Recall Bulletin

PRODUCT SAFETY RECALL

SUBJECT: Electric Power Steering Assist

Serviced under Safety Recall 10023 Prior to May 31, 2010

Power Steering Assist Motor Housing Inspection -- All Vehicles Except Chevrolet HHR

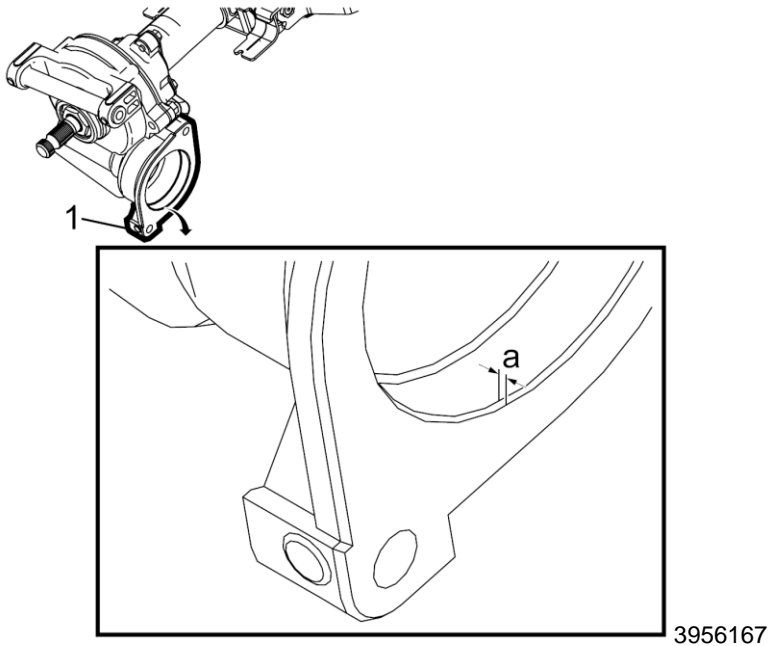
Caution: First design steering motor with a small chamfer does not require a seal. If a seal is installed on a first design steering motor, potential damage to the steering motor may occur resulting in loss of assist steering. Seal is only required for the second design steering motor with the larger chamfer. Before installing the power steering assist motor, inspect the power steering assist motor housing (1) to verify the steering column design.

- *First Design:* If the chamfer (a) is **1 mm (0.04 in)** and **30 degrees** then the steering column is the first design and a power steering assist motor O-ring seal is NOT needed.
- *Second Design:* If the chamfer (a) is **2.7 mm (0.11 in)** and **45 degrees** then the steering column is the second design and a NEW power steering assist motor O-ring seal IS needed.
